Object

Summary

The many deficiencies in the development design proposals and methodology mean the standard for discharge of conditions has not been met, and the proposed development should not be permitted.

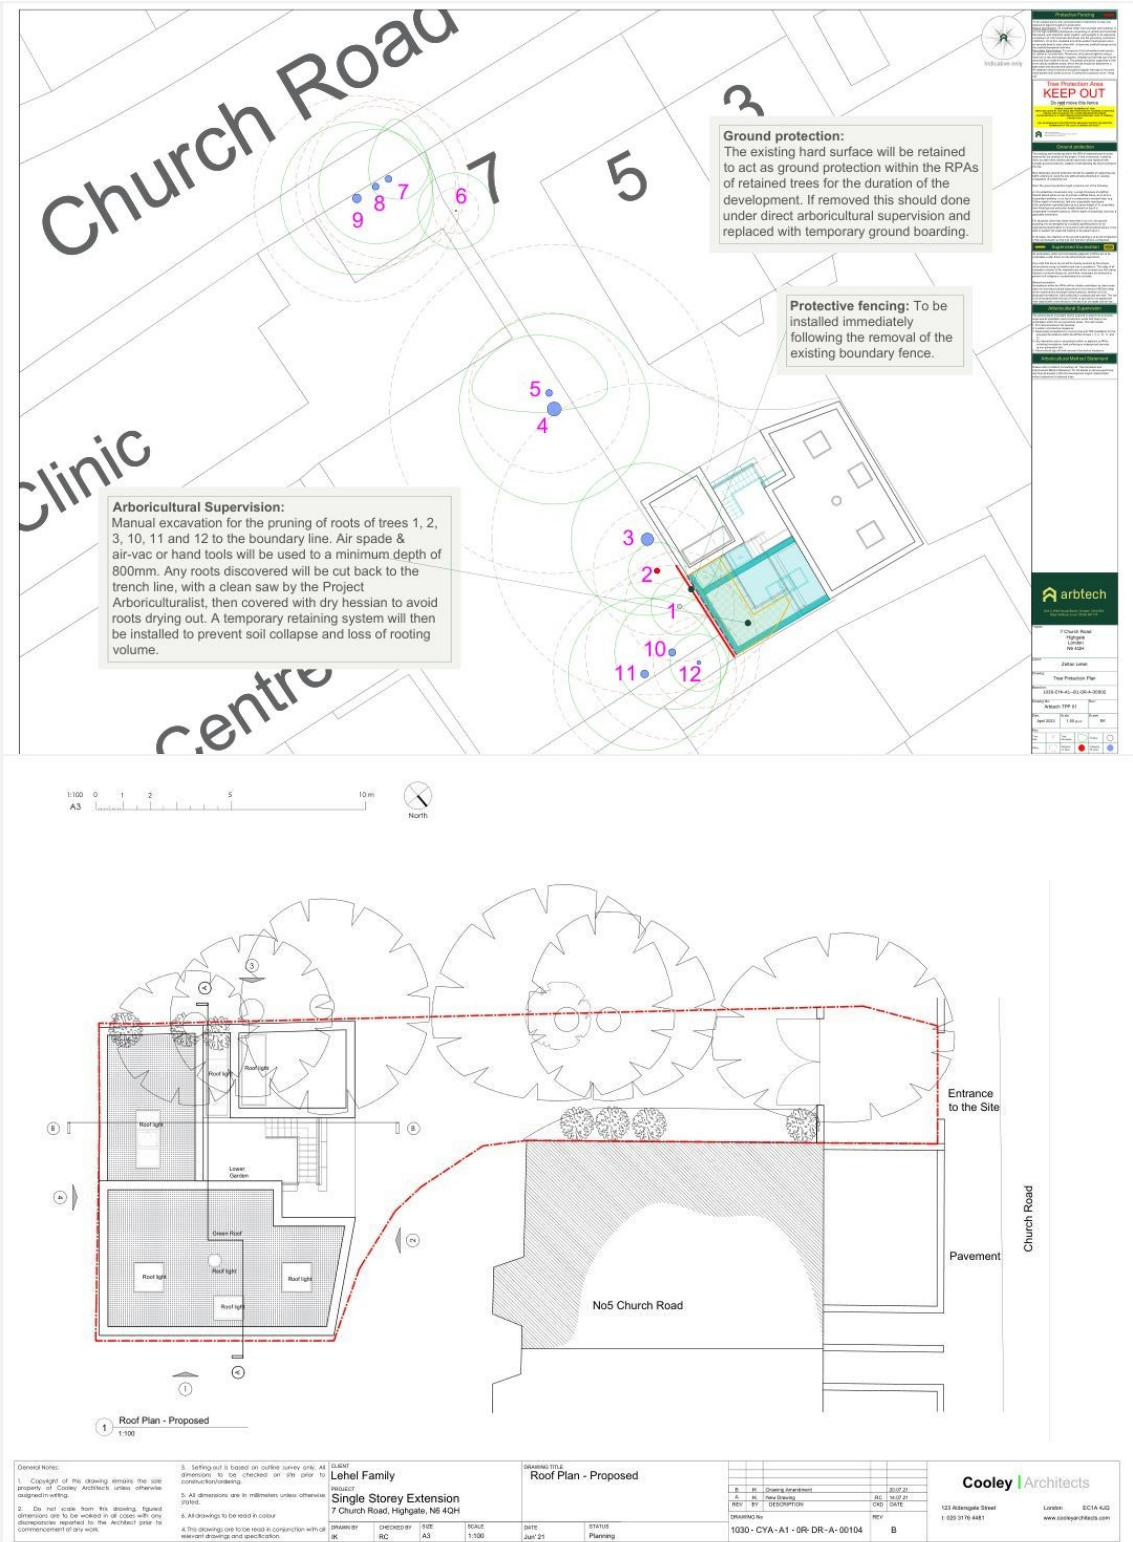
The methods proposed for the work at 7 Church Road are in complete conflict with the future development of these trees.

The life expectancy of a Lime tree is 200 - 300 years. Severing roots is not compatible with ensuring the long term health of the affected trees over their expected lifespan, over which time, roots left to grow naturally would increase in diameter and length.

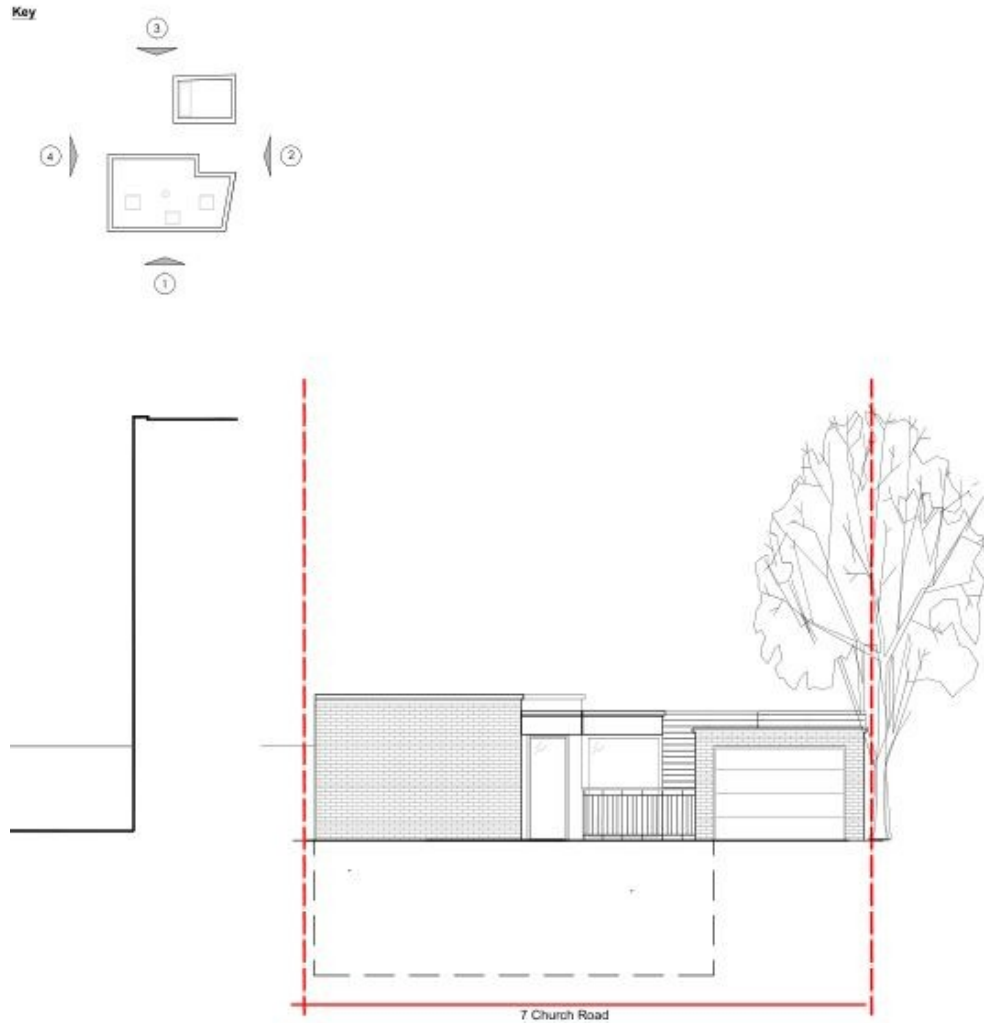
The approaches laid out in the Method Statement also do not take account of the history of the site.

The vertical drop between the site and the ground containing the trees is indicative of a substantial change in ground profile caused by excavation. In normal growing conditions, the vast majority of the roots of a mature trees are found in the top 300 mm of soil. The finding of a high number of roots at a depth of 600 mm or deeper below the level of the ground on the other side of the boundary is strongly suggestive of compensatory root development to achieve anchoring, water and nutrition on that side of the trees. If the large change in ground profile occurred in 2015-2016, then the root development photographed has occurred at this unusual depth in just the subsequent 7 years. It is inevitable that the root diameters are small

at this time, and equally, that the roots that have been found could be expected to increase substantially in diameter over the many decades of future growth of these trees.
